### **ADDENDUM #3**

#### **Rye City School District**

***Issued: 2021-02-11***

**This Addendum No. 3 forms part of the Contract Documents and modifies the original bidding documents dated, January 19, 2021.**

AVE2-102

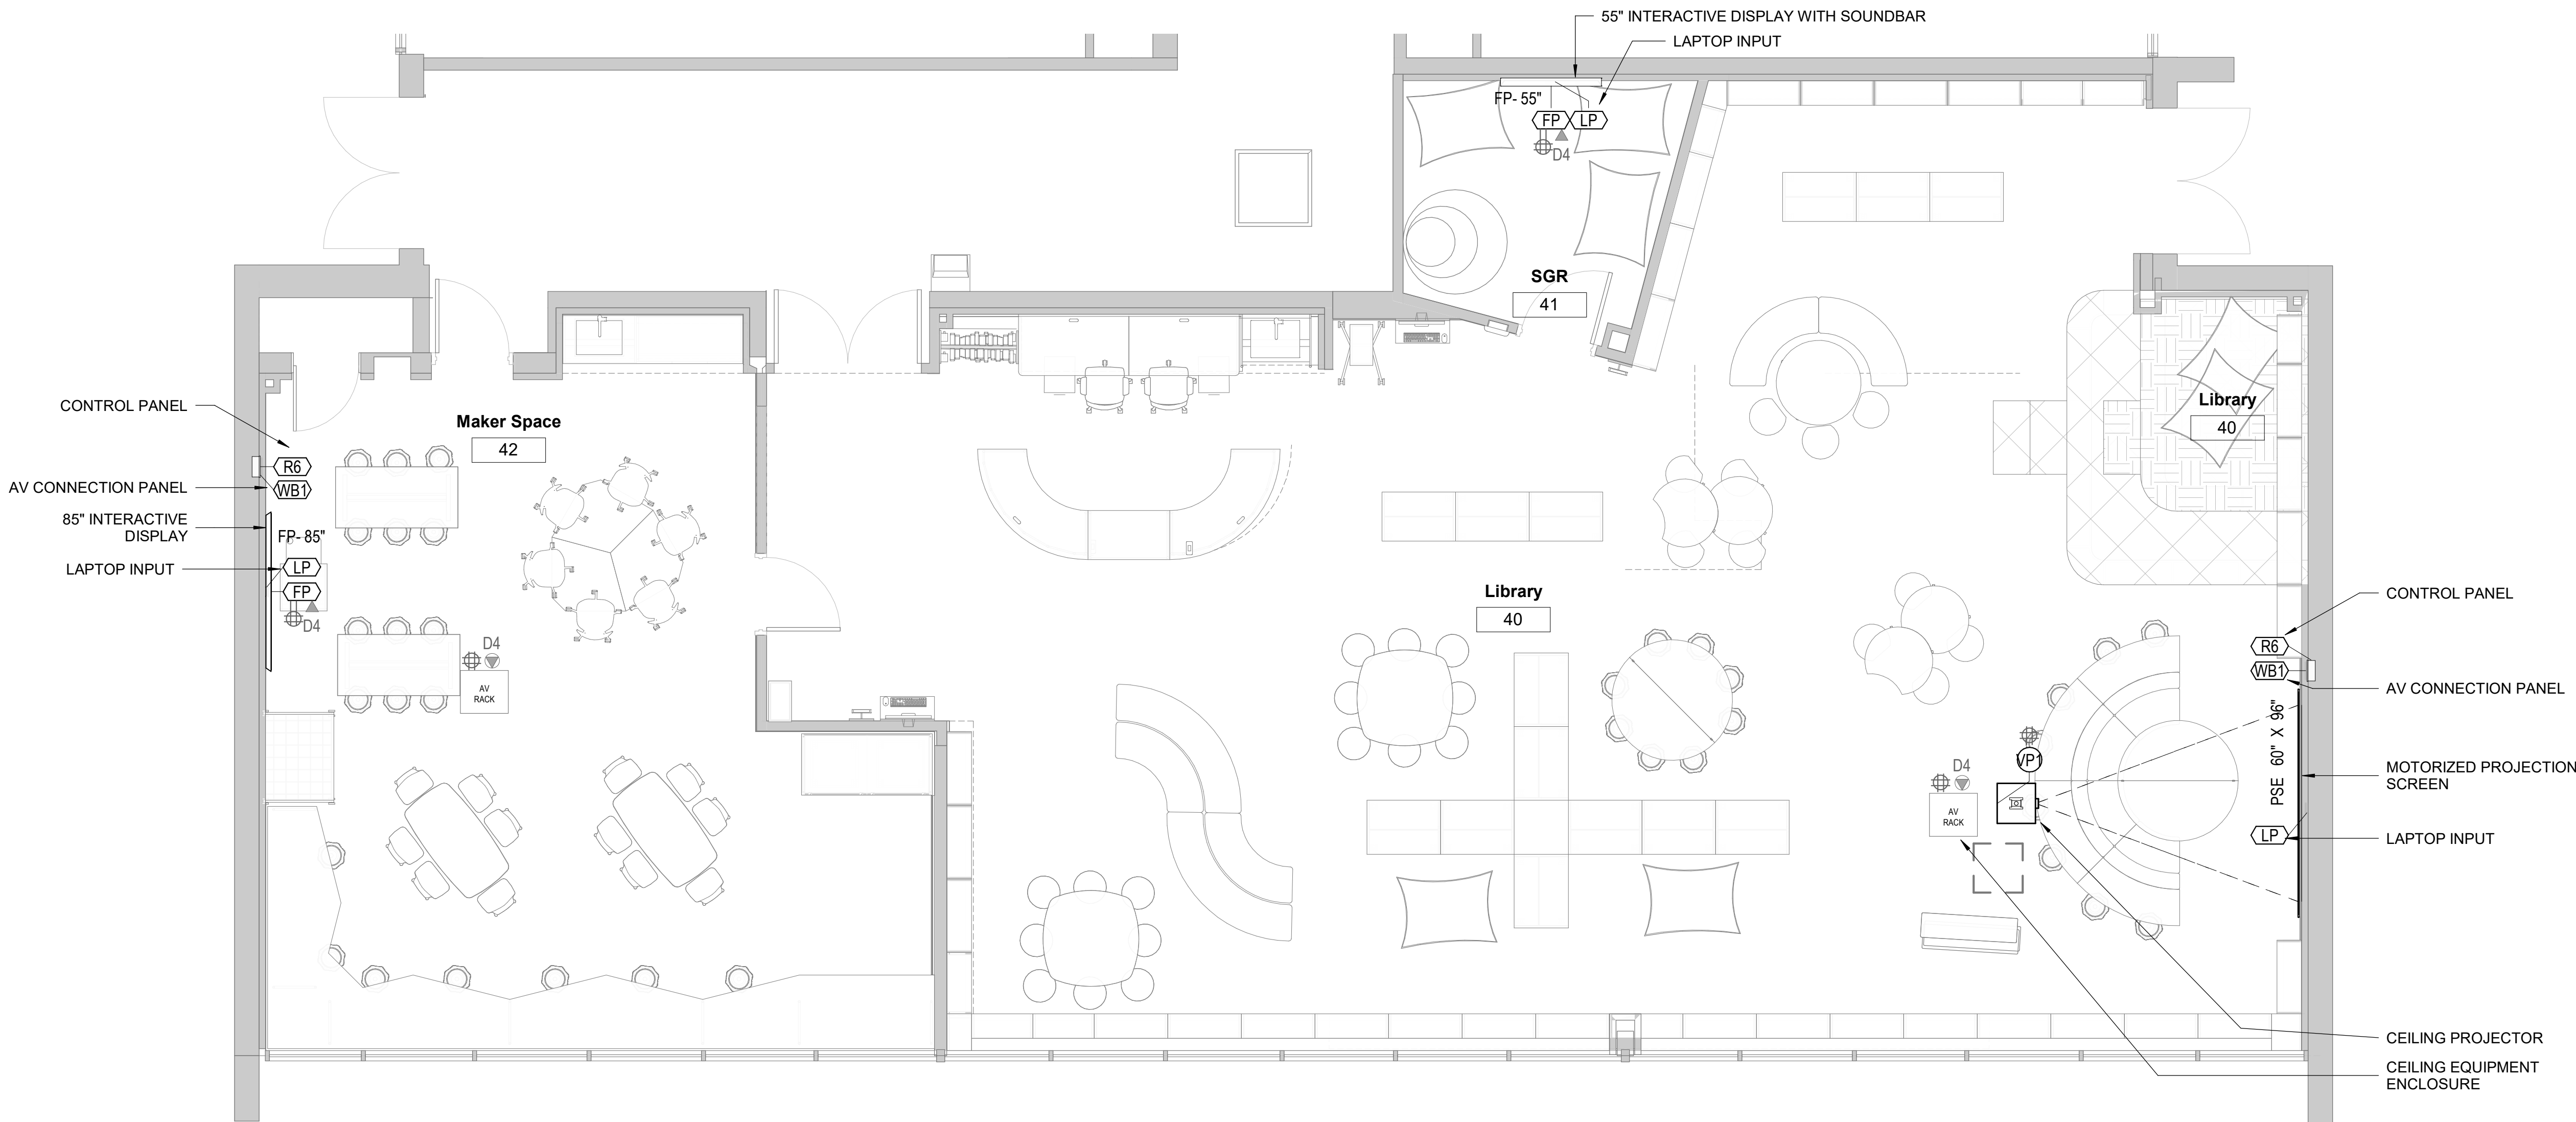
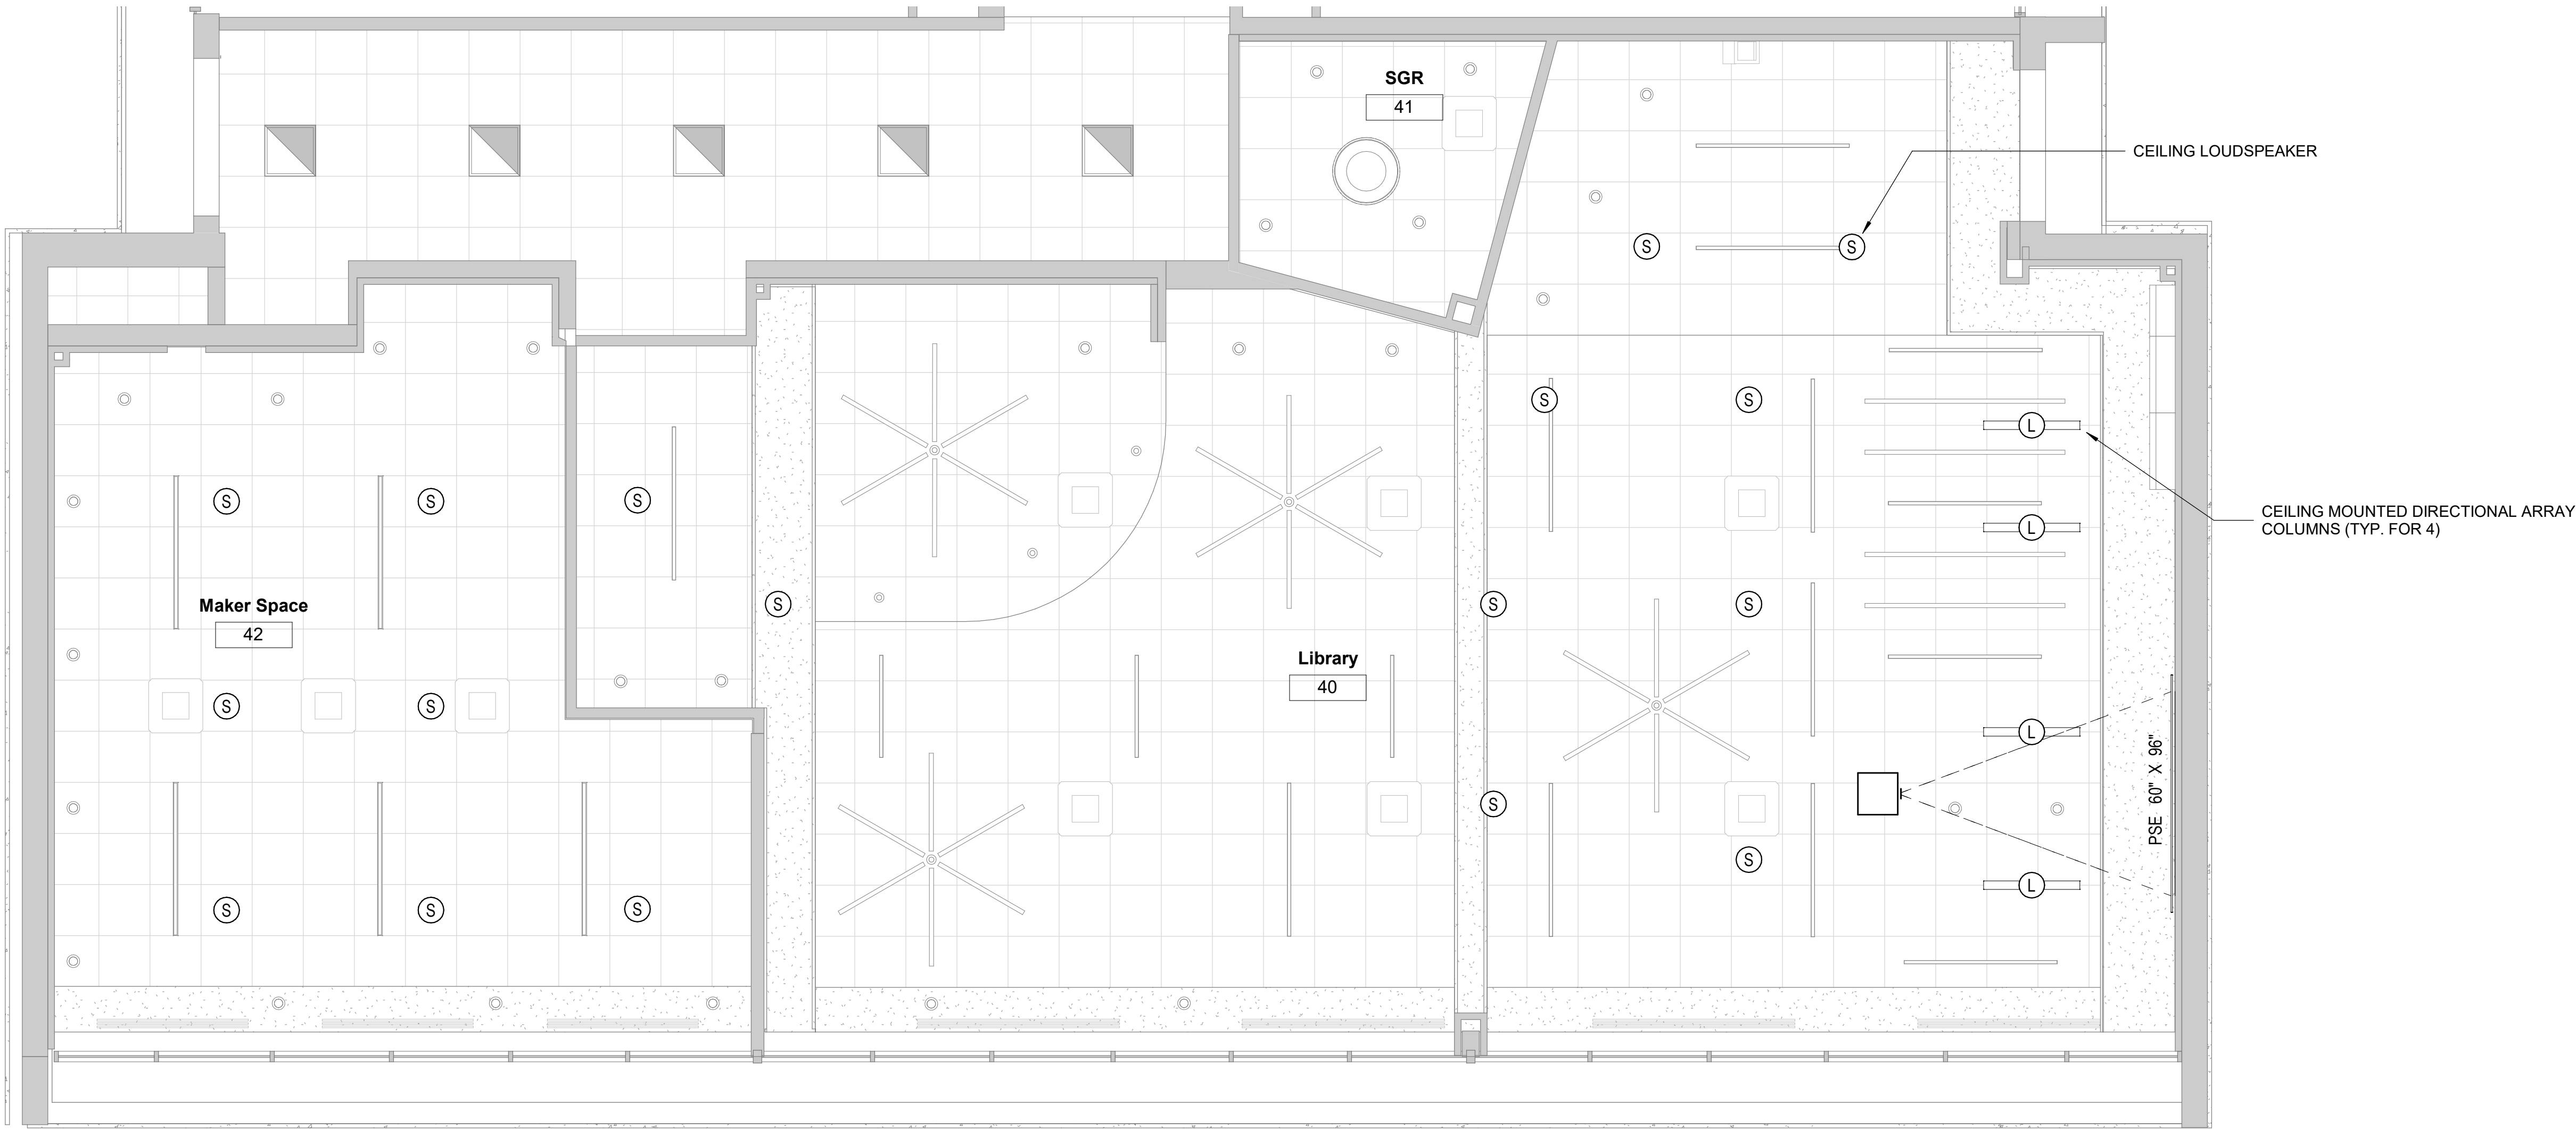
1. AVE2-001
  - a. Notes have been added to these drawings to clarify the scope of work between EC and Owner's AV vendor.
2. AVE2-102
  - a. Notes have been added to these drawings to clarify the scope of work between EC and Owner's AV vendor.
3. AVE2-112
  - a. Notes have been added to these drawings to clarify the scope of work between EC and Owner's AV vendor.
4. AVE2-202
  - a. Notes have been added to these drawings to clarify the scope of work between EC and Owner's AV vendor.

AVE2-112

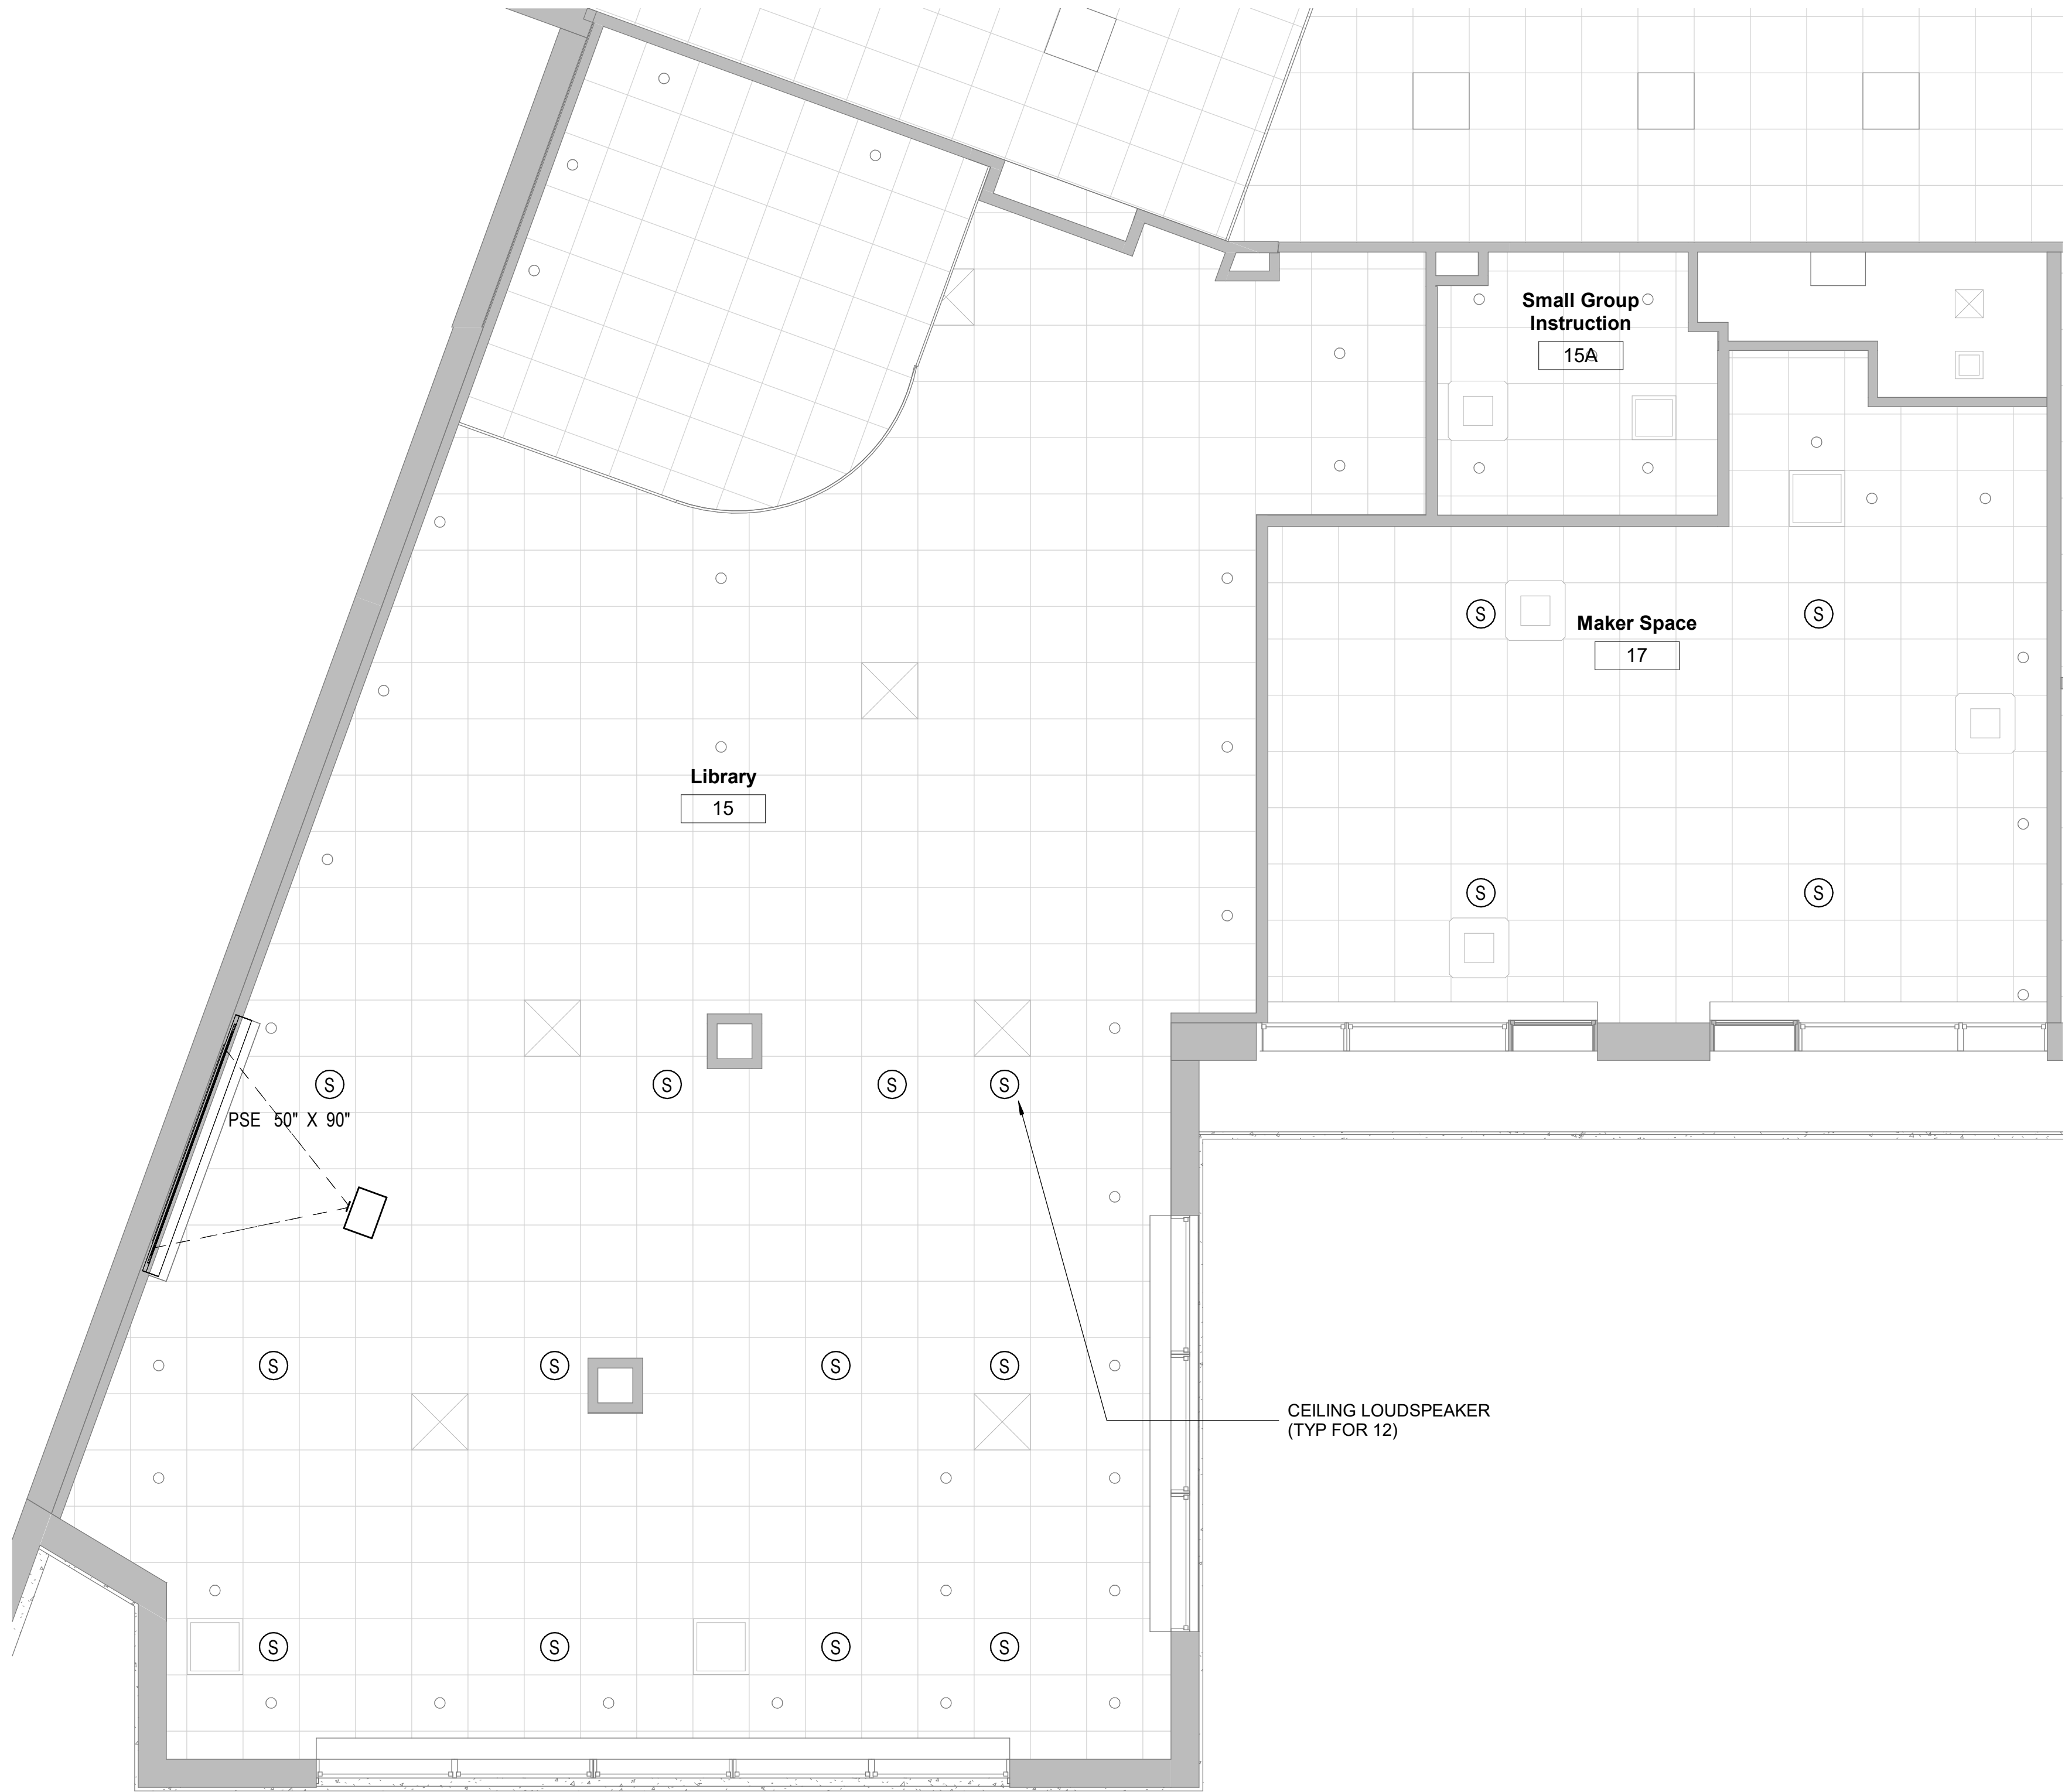
5. AVE2-112
  - a. Notes have been added to these drawings to clarify the scope of work between EC and Owner's AV vendor.
6. AVE2-201
  - a. Notes have been added to these drawings to clarify the scope of work between EC and Owner's AV vendor.
